AMENDED PRELIMINARY PLAT
FOR
UNITS 4, 5 AND 6
PAINTED SKY SUBDIVISION

TITLE: PAINTED SKY SUBDIVISION UNITS 4, 5 & 6 AMENDED GRADING AND DRAINAGE PLAN

TITLE: PAINTED SKY SUBDIVISION UNITS 4, 5 & 6 AMENDED GRADING AND DRAINAGE PLAN

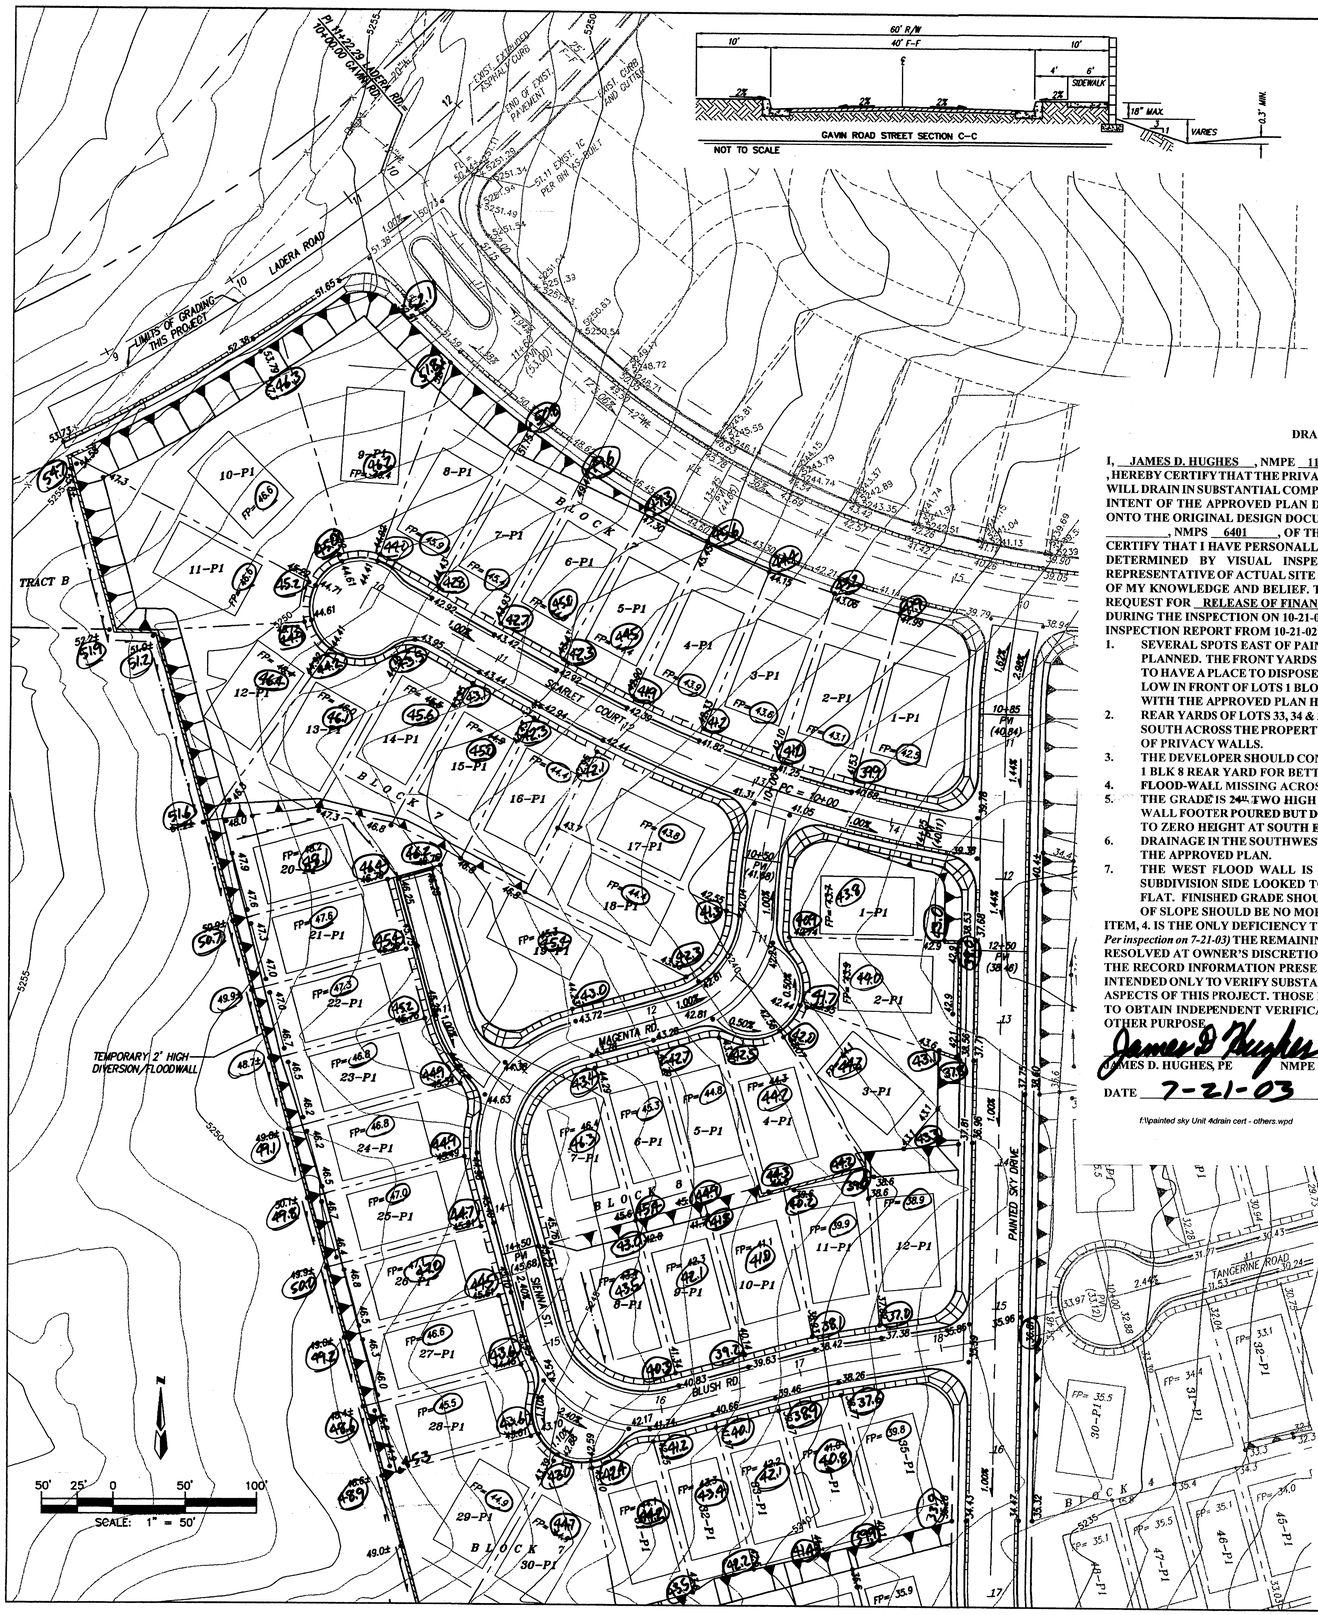
1. SEVERAL SPOTS EAST OF PAINTED SKY PLACE WERE MORE THAN 18" LOWER THAN PLANNED. THE FRONT YARDS WERE INTENTIONALLY LEFT LOW FOR THE BUILDERS TO HAVE A PLACE TO DISPOSE OF FOOTER EXCAVATION (SEE LOT 73 BLOCK 2). ALSO LOW IN FRONT OF LOTS 1 BLOCK 8, AND LOT 7 BLOCK 7. SUBSTANTIAL COMPLIANCE WITH THE APPROVED PLAN HAS BEEN ACHIEVED.

6. DRAINAGE IN THE SOUTHWEST CORNER OF UNIT 5 WAS SLIGHTLY DIFFERENT THAN THE APPROVED PLAN.
7. THE WEST FLOOD WALL IS APPARENTLY COMPLETE, BUT THE SLOPE ON THE SUBDIVISION SIDE LOOKED TOO ROUGH, LOOSE AND LOW. IT ALSO LOOKED TOO FLAT. FINISHED GRADE SHOULD BE THE SAME ON BOTH SIDES OF THE WALL. TOE OF SLOPE SHOULD BE NO MORE THEN 10' FROM THE WALL.
